IPC-2221

Generic Standard on Printed Board Design

Amendment 1

Amendment 1
January 2000

Figure 12-20 Test Specimen X, mm [in]

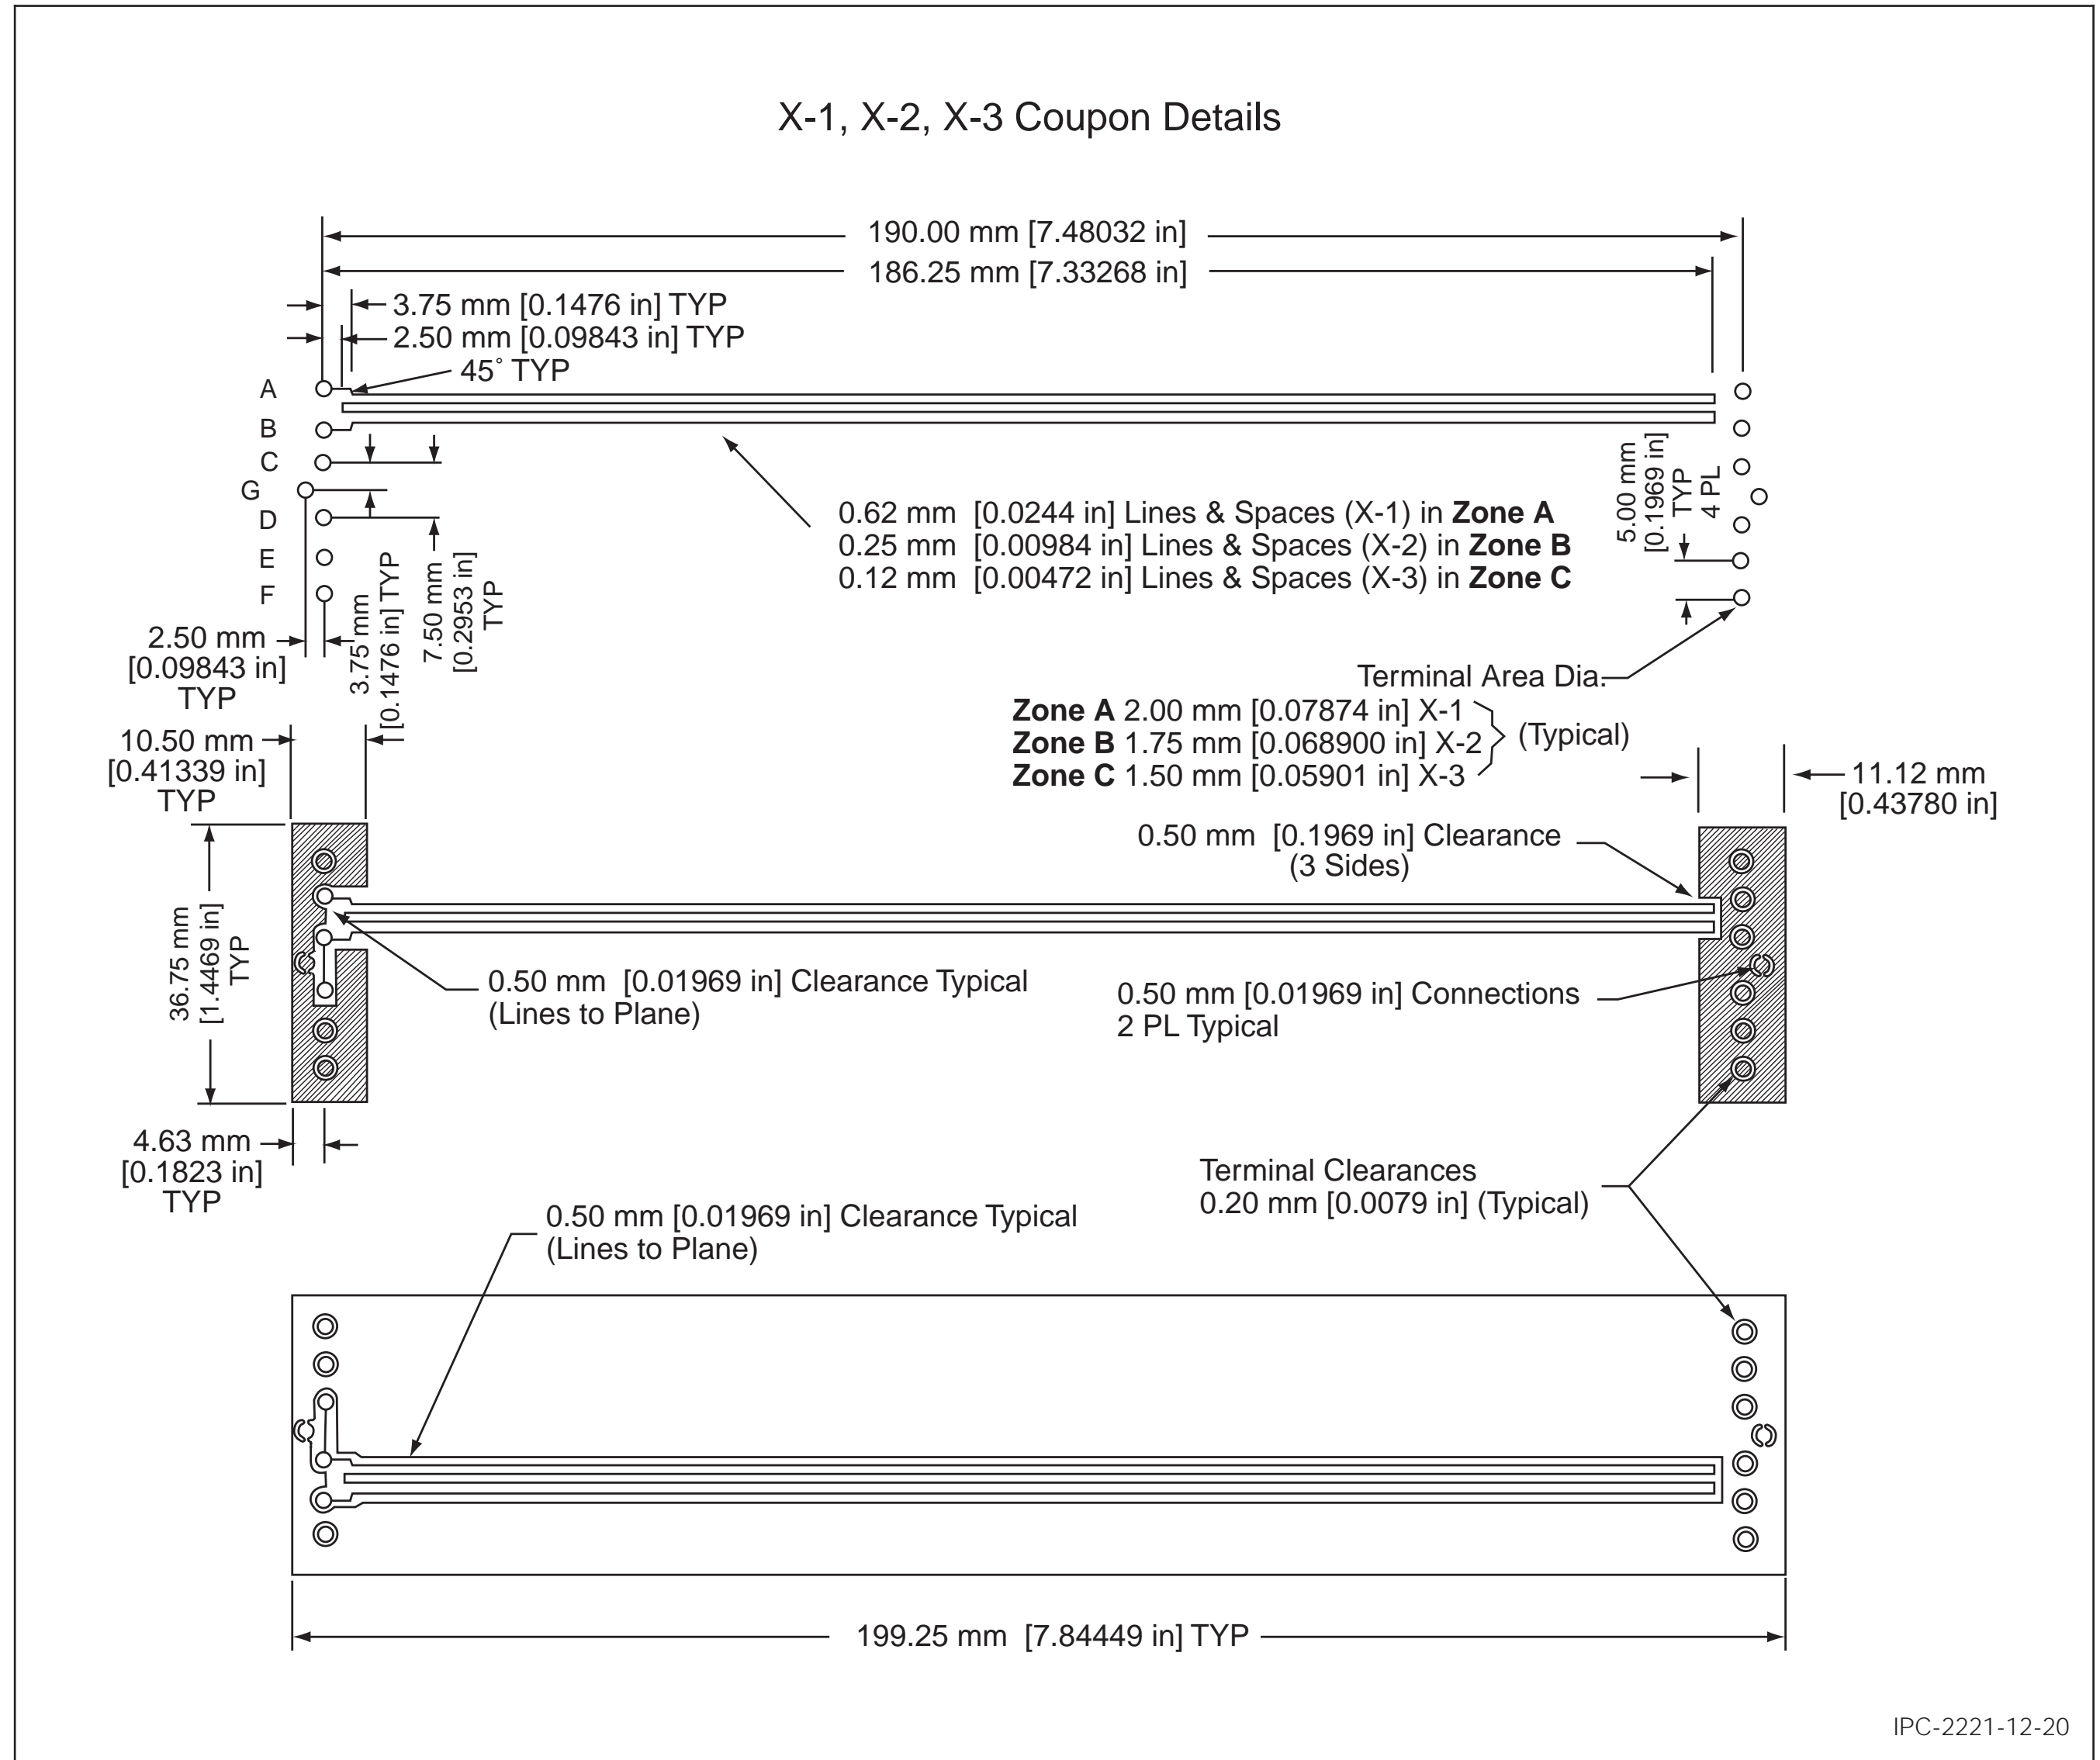
Add new Para 12.4.12 Specimen X This specimen **shall** be used to validate bending flexibility and bending endurance of flexible printed wiring applications. This specimen is typically used for qualification and/or acceptance testing of flexible products designed for installation use B (dynamic flex). The specimen should represent the circuit conductor characteristics of the actual design. The outline of the specimen as shown in Figure 12-20 **shall not** be deviated from in order to accommodate the test method fixture. The number of minimum flex life cycles should be specified on the master drawing. Refer to IPC-2223 for specific design flexibility guidelines.

Insert Figure 12-20 as follows:
